HOWARD COUNTY HEALTH DEPARTMENT
BUREAU OF ENVIRONMENTAL HEALTH
3525-H ELLICOTT MILLS DRIVE/ELLICOTT CITY, MARYLAND 21043
TELEPHONE: 313-2640

SUBJECT: Vineyards At Cattail Creek
Lot No. 5 Sewerage Reservation
RECONFIGURATION

SUBJECT: Vineyards At Cattail Creek
Lot No. 8 Sewerage Reservation
RECONFIGURATION

SHEET 3

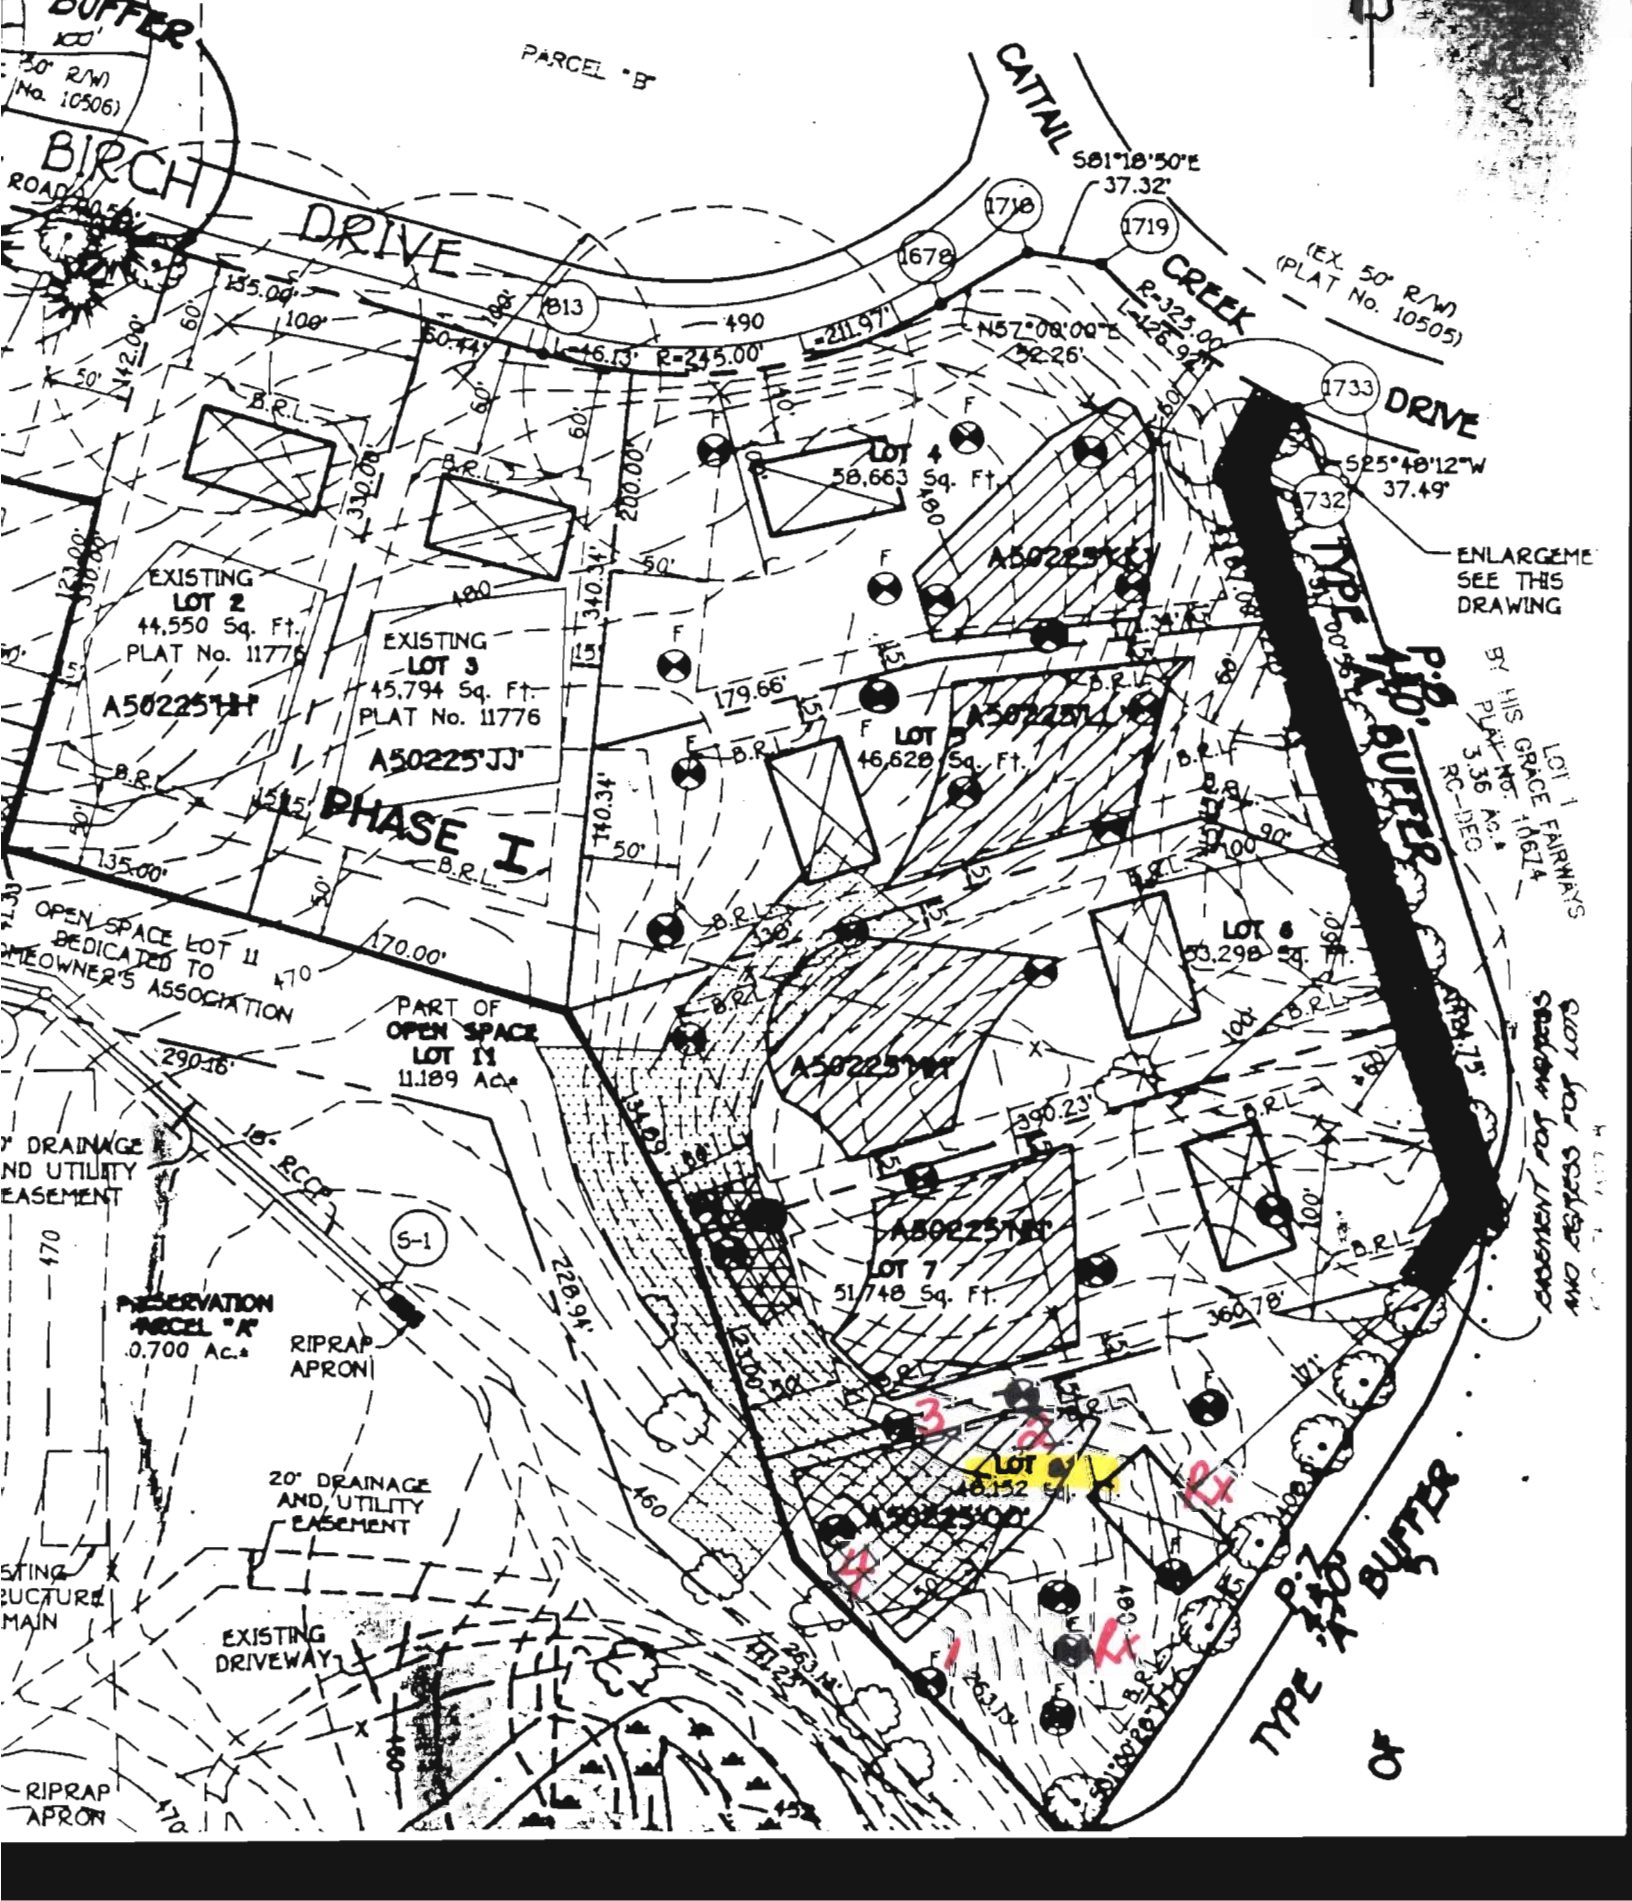
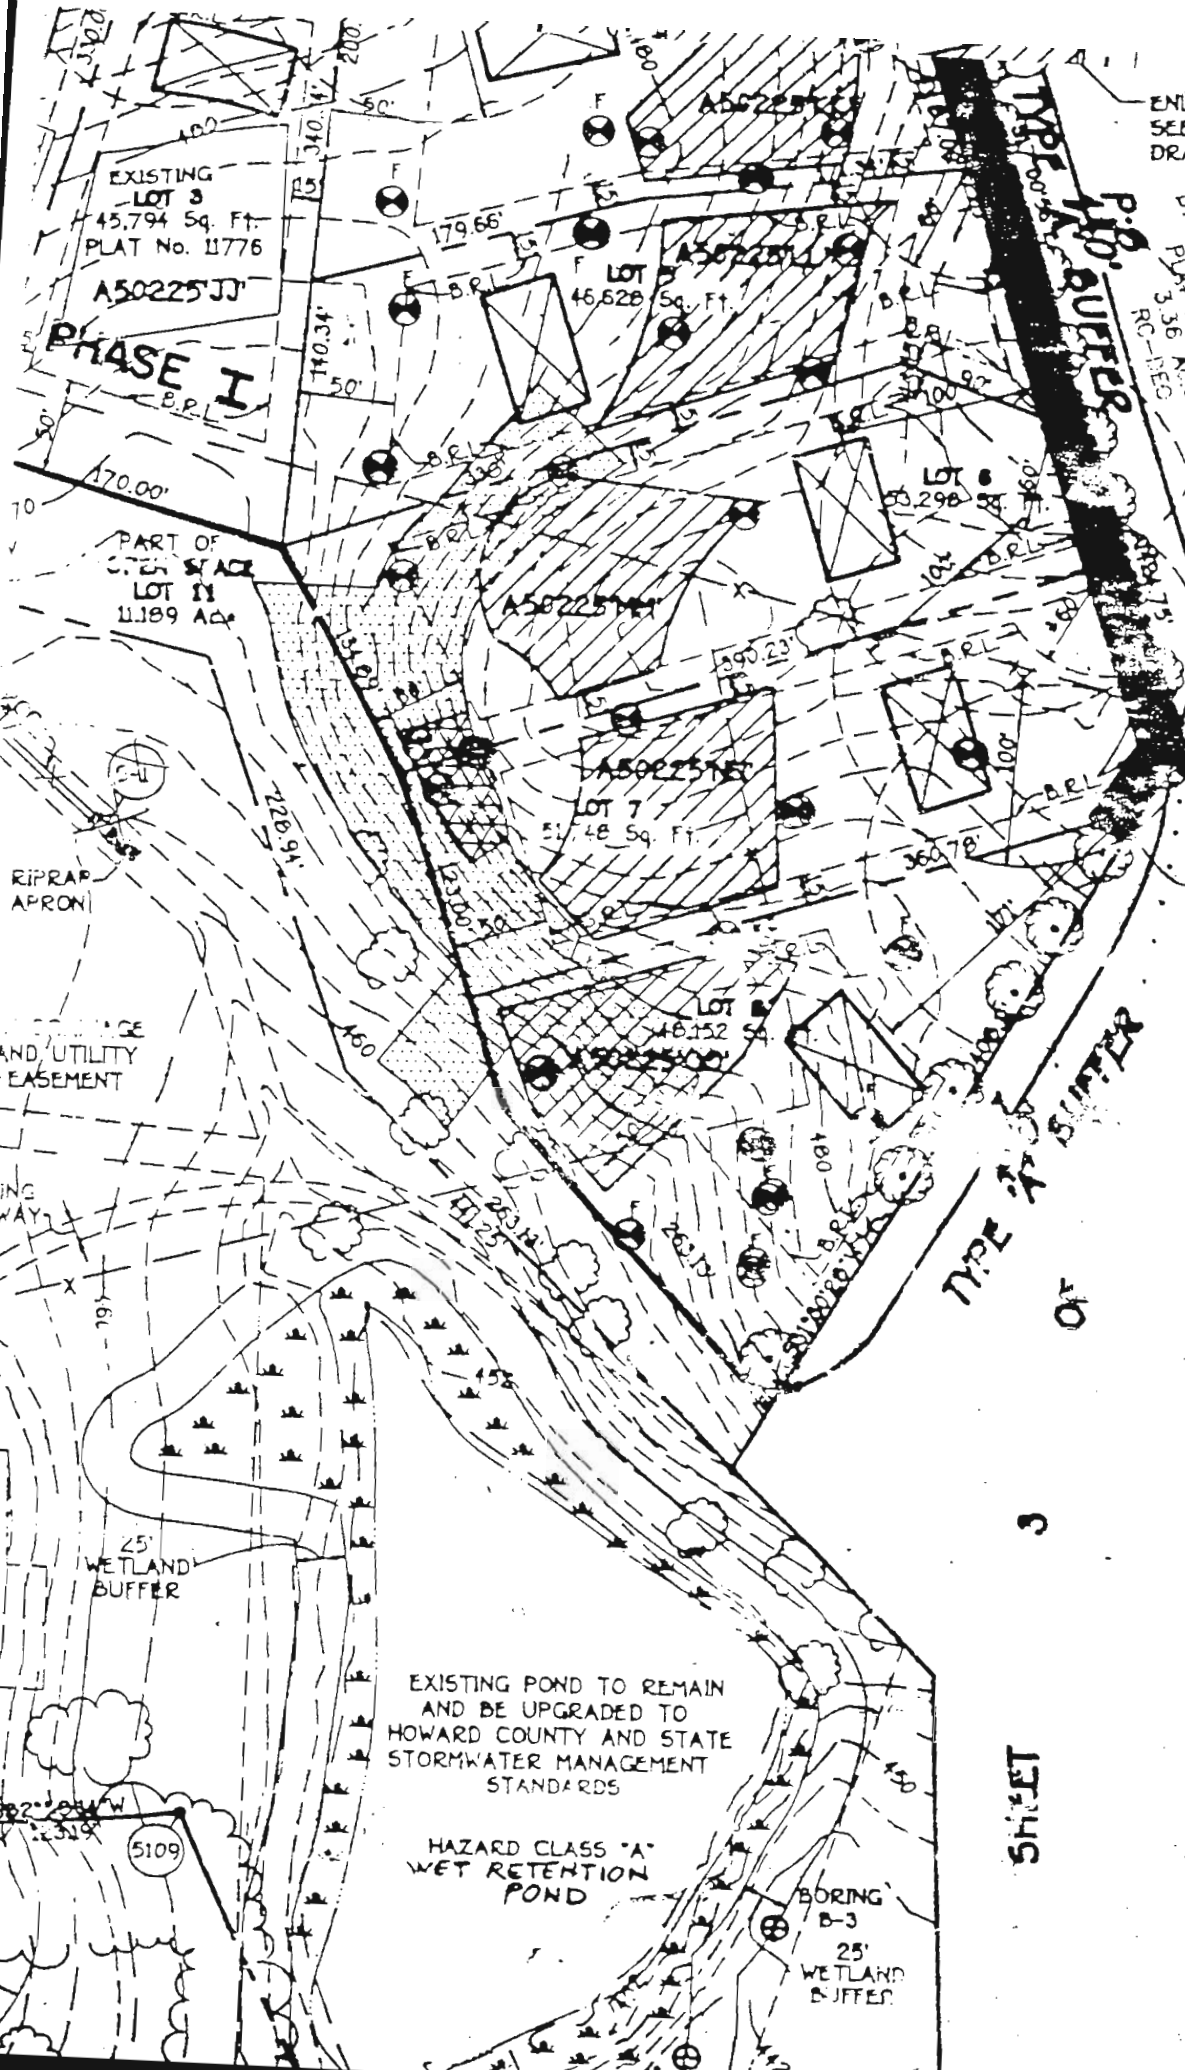
My client Mr. Chris Rachuba is purchasing Lot No. 5 of Cattail Creek and he wants to build a 193'x65' house on the lot. (see copy of Health Dept. Plan enclosed) Would you check your files and let CRC know if it is possible to reconfigure the sewerage reservation to accomodate the proposed dwelling.

My client Mr. Chris Rachuba is purchasing Lot No. 8 of Cattail Creek and he wants to build a 103'x68' house on the lot. (see copy of Health Dept. Plan enclosed) Would you check your files and let CRC know if it is possible to reconfigure the sewerage reservation to accomodate the proposed dwelling.

**PROPOSED NEW AREA
PREVIOUSLY FAILED FOR ROCK,
BUT WE WOULD NOT BE OPPOSED
TO A REQUEST FOR RE-EVALUATION
THAT INCLUDED OPPORTUNITY TO
RECONFIRM PORTIONS OF THE
PROPOSED AREA. 4/18/00 (CW)**

I would not be optimistic about the chances of approval of any proposal for adjustment of the sewage disposal area on this lot. Each of the test holes labeled "F" outside the disposal area are listed as having failed due to shallow depth to bedrock, and the swale just to the right of designated disposal area appears, at least on paper, to be a feature to be avoided.

But neither would I definitively rule out the possibility of an adjustment, both factors (excess rock and swale) are sometimes more judgemental than one might think.

Percolation testing would certainly be required; enclosed is a test application to complete and return (\$225 test fee ± backhoe) if interested in having testing scheduled.

My uncertain expectation on the likelihood for approval if tested - 15% chance of success.
